3. Midtown Project - Somerset Street

**LEGAL ADVERTISEMENT
PORTLAND PLANNING BOARD MEETING**

To: Stuart O'Brien, Chair and Members of the Portland Planning Board
From: Richard Knowland, Senior Planner
Date: November 7, 2014
Re: Midtown; 59 Somerset Street, The Federated Companies
Project #: 2014-203 **CBL:** 34-B-2, 3, 4, 5; 34-D-3, 8
Meeting Date: November 12, 2014

ENGINEERS FST Since 1954		FAY, SPOFFORD & THORNDIKE, INC. ENGINEERS • PLANNERS • SCIENTISTS 778 MAIN ST., SUITE 8, SOUTH PORTLAND, ME 04106 FORMERLY DELUCA-HOFFMAN ASSOCIATES, INC.	
DRAWN: KEW	DATE: NOV. 2012	DESIGNED: WGH	SCALE: 1" = 20'
CHECKED: WGH	JOB NO. 3062	FILE NAME: 3062-GRADE	
SHEET	C-3.1

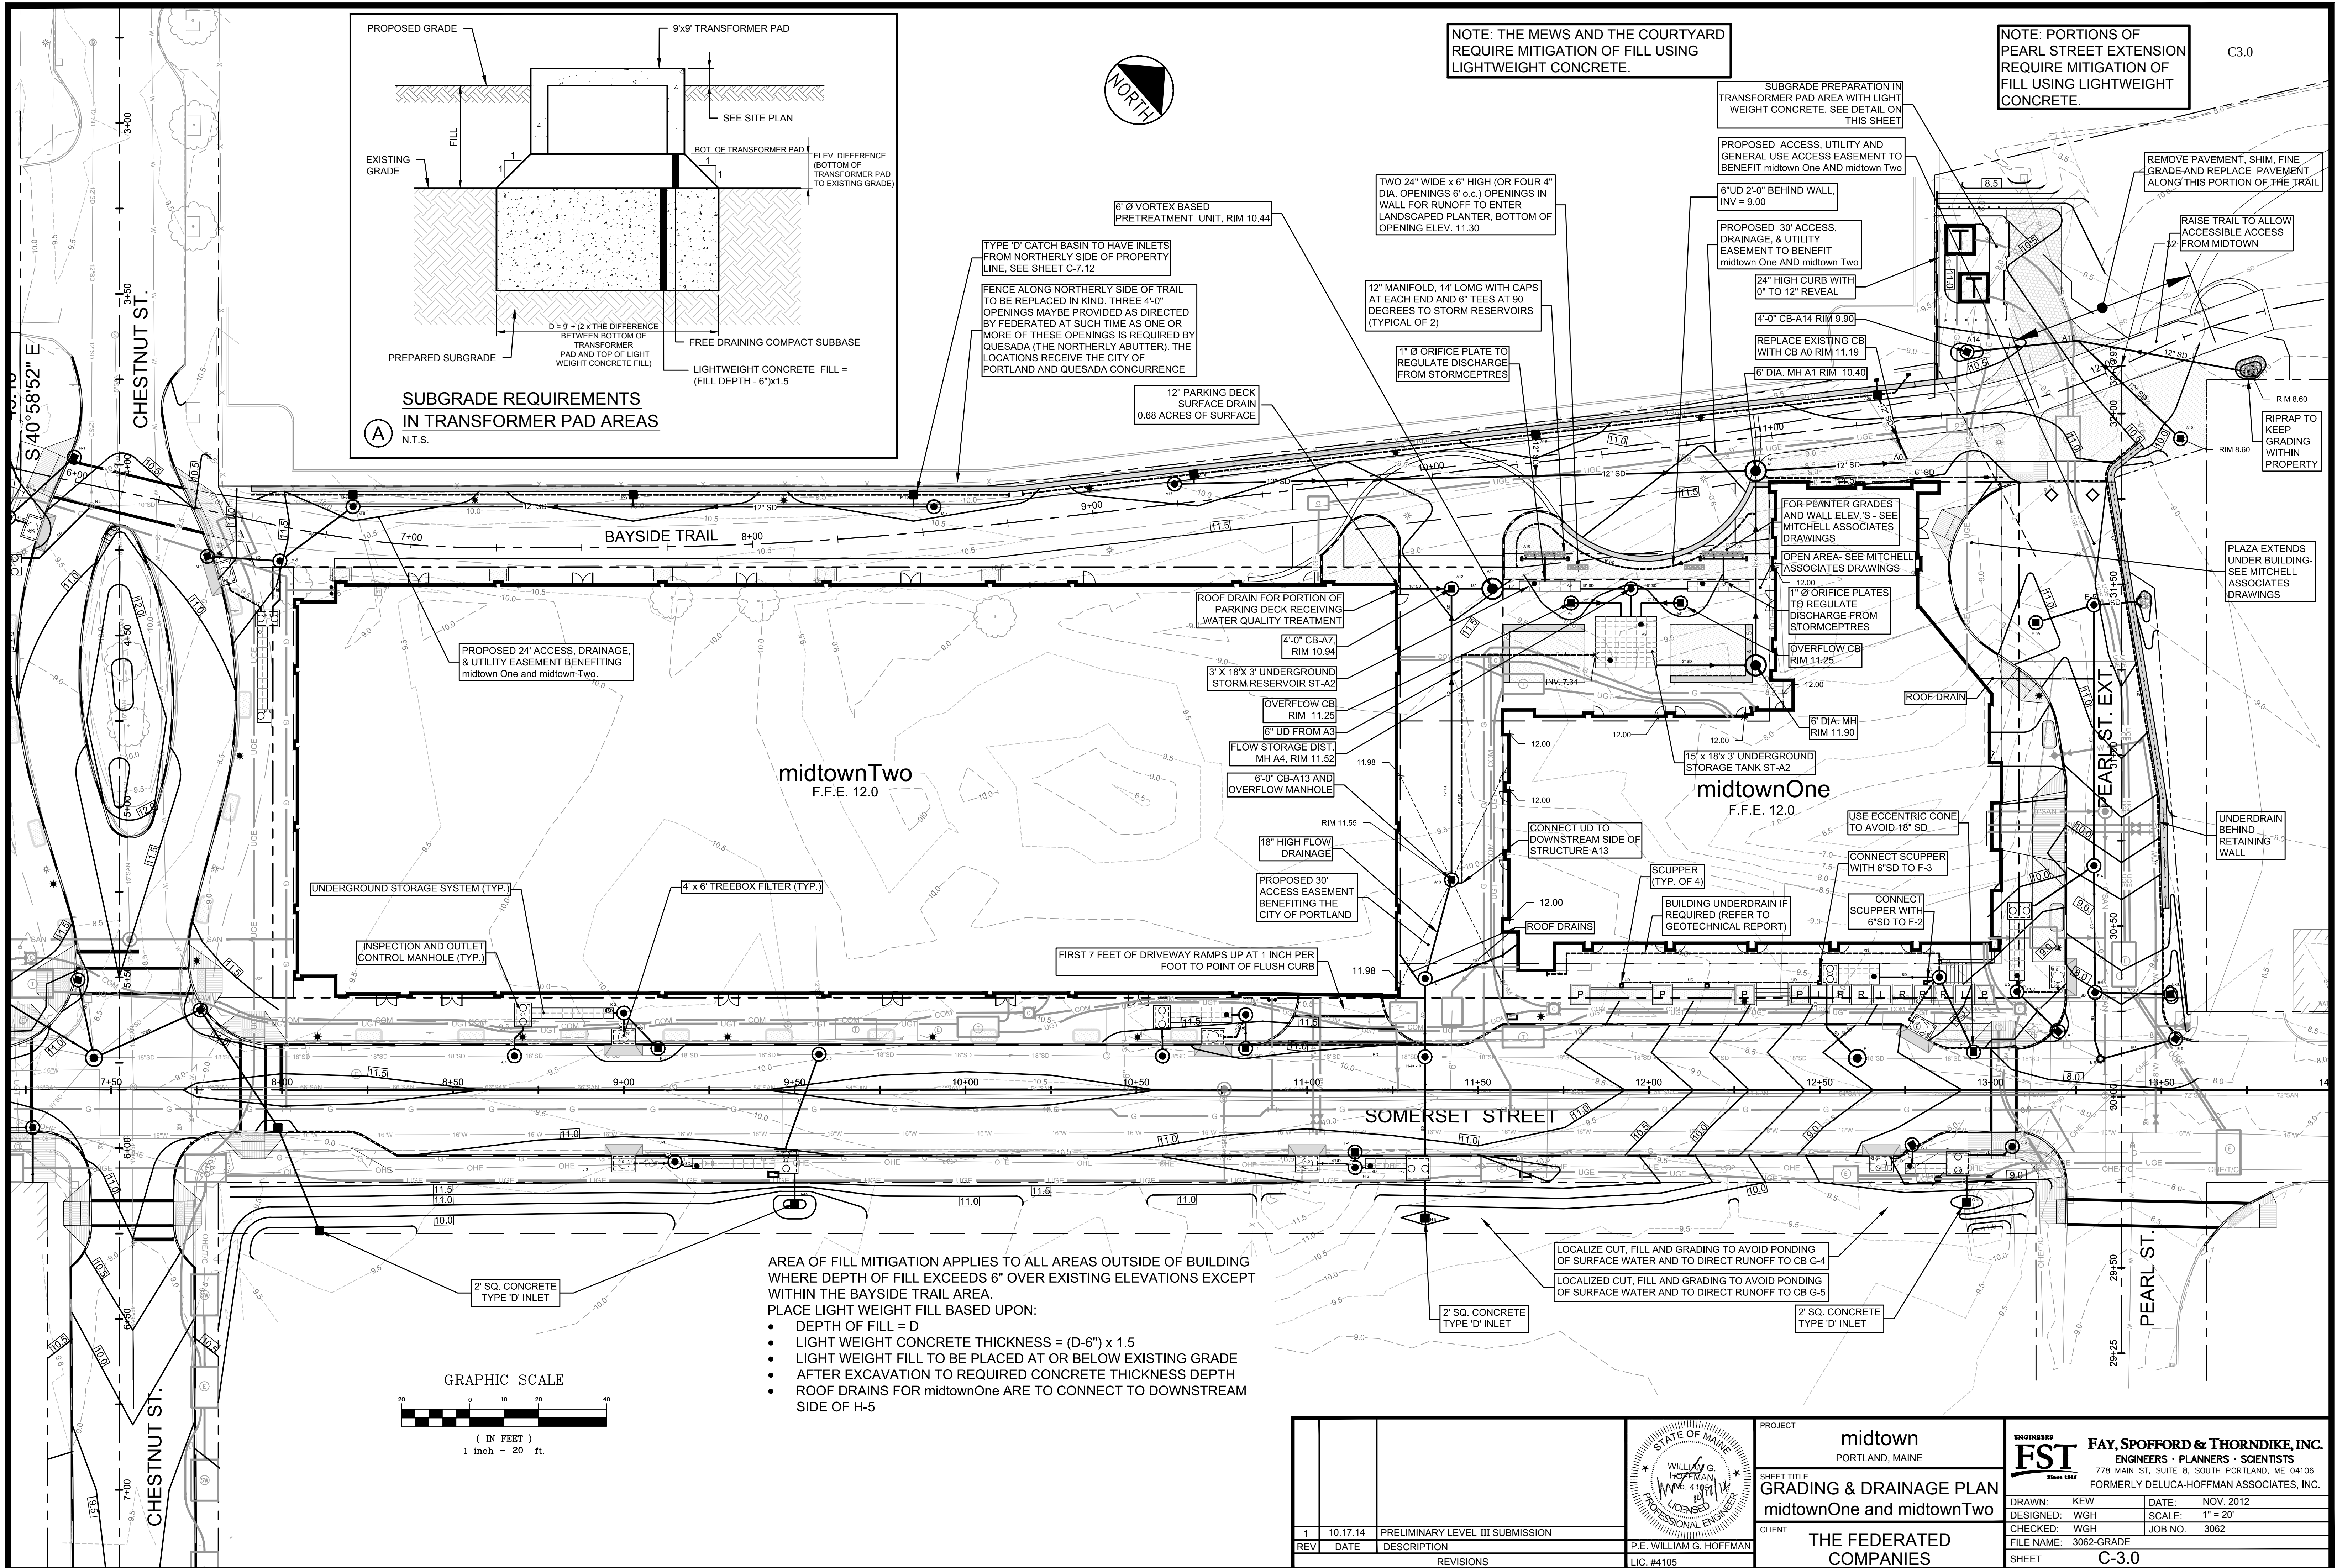
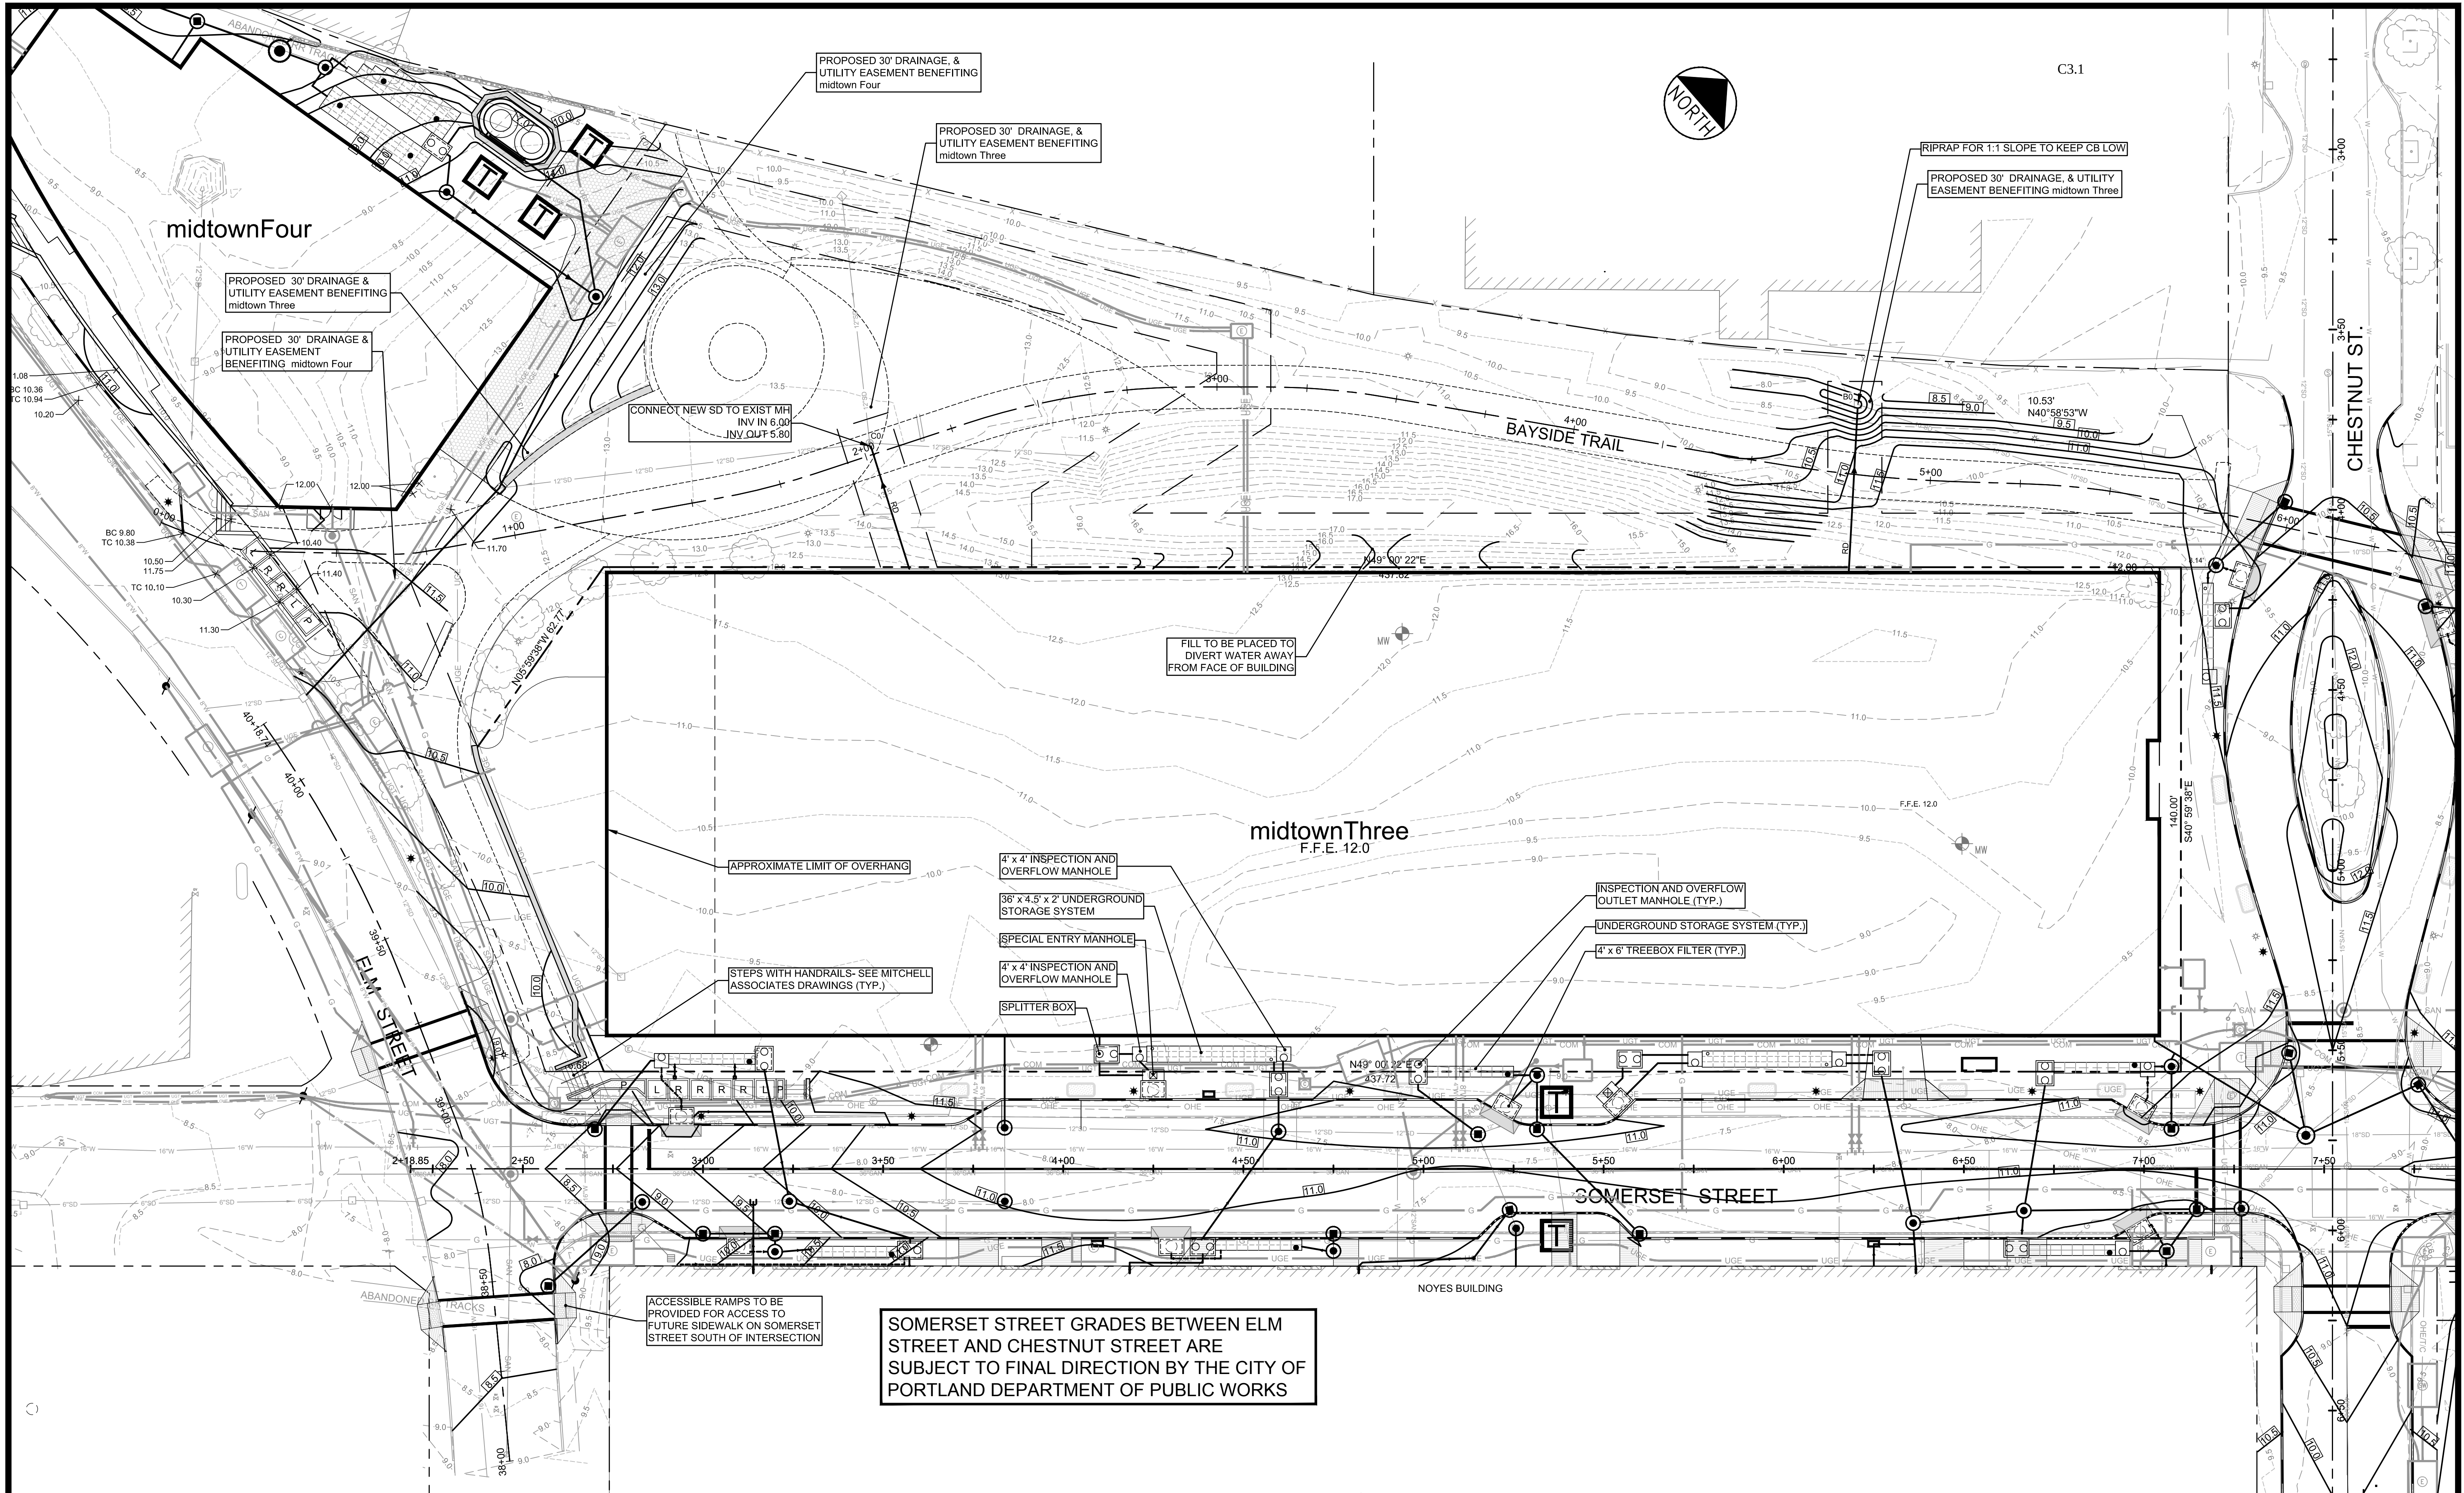
- a. For the curb ramps on the north side of Somerset St at Chestnut St please include a minimum 4' separation between the tipdown curbing at the corners as shown in your typical detail (Sheet C-7.1. , C). **Addressed**

- b. Curb Extension detail (Sheet C-7.1. , J) shows 6' tipdowns whereas the drawings (Sheets C-2.1 to C-2.3) seem to show 7' tipdowns at the flares for the curb ramps. Please clarify. **No revised Curb Extension Detail drawing found – potentially unaddressed.**

- d. The curb ramps on Somerset St at the corner of Elm St do not appear to provide a 4' landing area at the top of the ramp. Please indicate how the sidewalk will achieve ADA compliance for the pedestrian access route (Sheet C-2.2). **The curb ramp landing area is addressed but not in a way to create a continuous ADA-accessible route along the east side of Elm Street.**

5. Please clarify the detail for the driveway for parking garage #1 on Somerset St. There does not appear to be an ADA-compliant pedestrian access route – the drawings seem to indicate tipdowns and sloped granite curb at the driveway edges (Sheet C-2.1). Similarly, please clarify the detail for the driveway for parking garage #2 on Somerset St. There does not appear to be an ADA-compliant pedestrian access route across the driveway along the sidewalk (Sheet C-2.2). **Did not find an updated Detail drawing; Sheet C1.5 (file name dated 12/19/13) continues to show 'mountable curb' where the ADA accessible route is shown on Sheet 2.0B.**

SHEET	C-4.0																																	
1	10.17.14	PRELIMINARY LEVEL III SUBMISSION																																
REV	DATE	DESCRIPTION	P.E. WILLIAM G. HOFFMAN LIC. #4105																															
REVISIONS

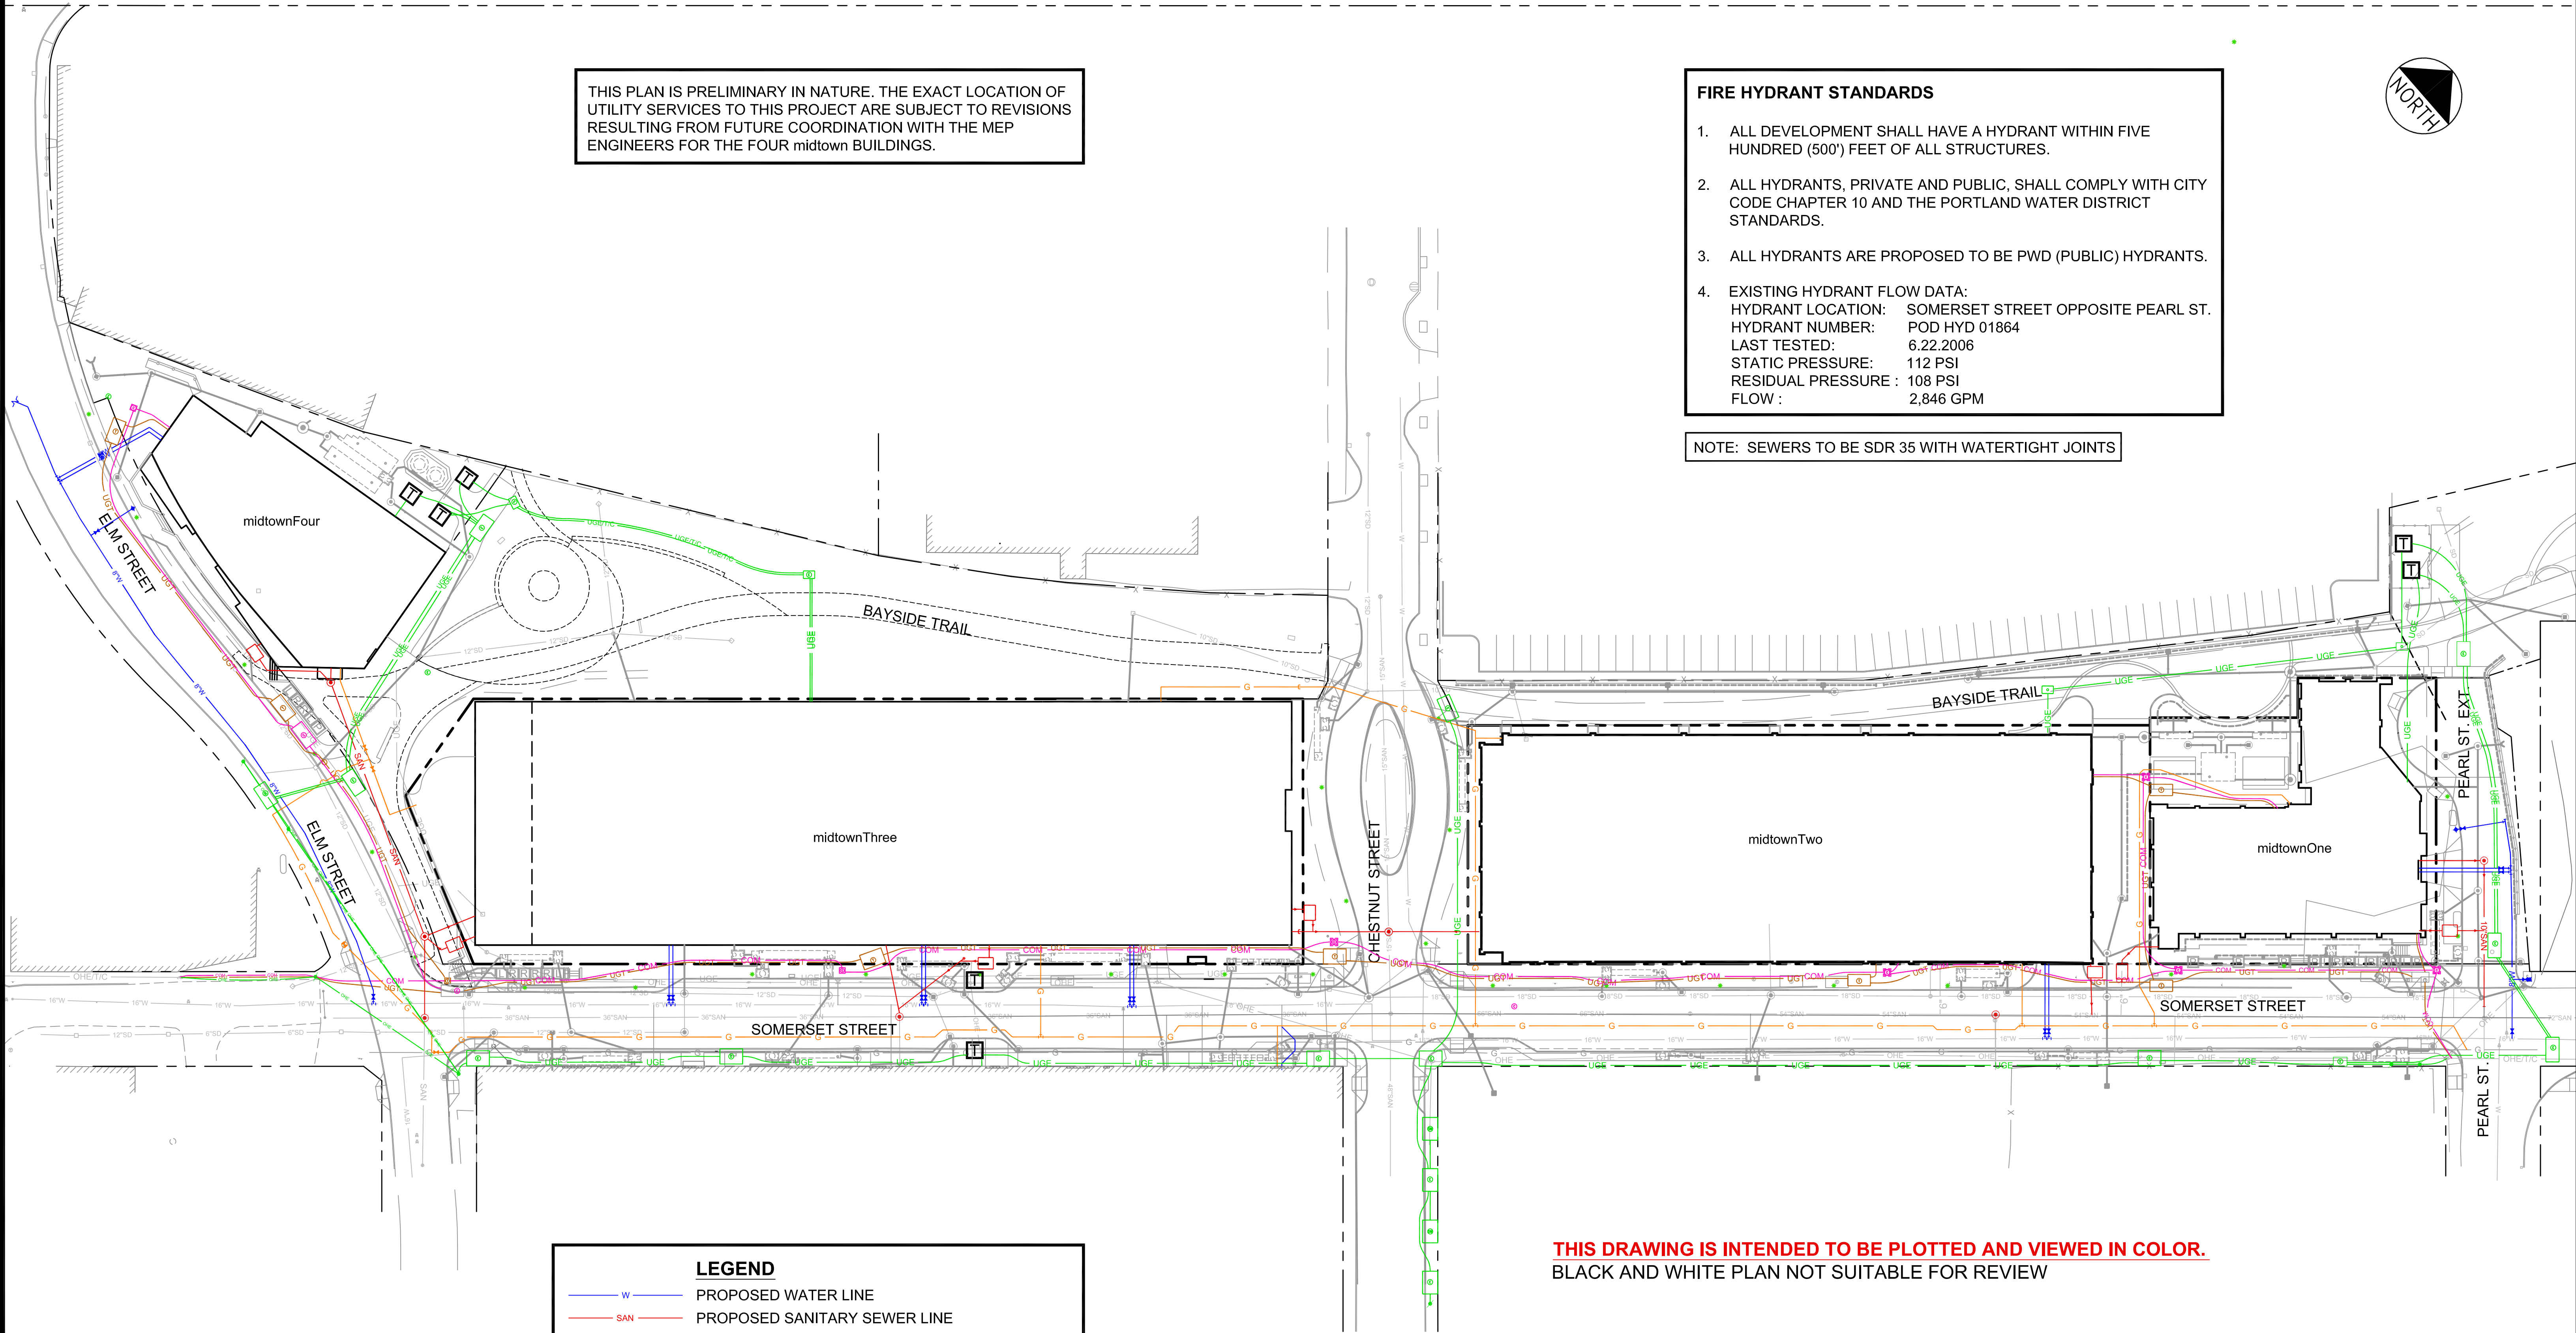
Hydrant locations are shown on Drawing C-4.0. This includes a new hydrant on Pearl Street Extension and Elm Street.
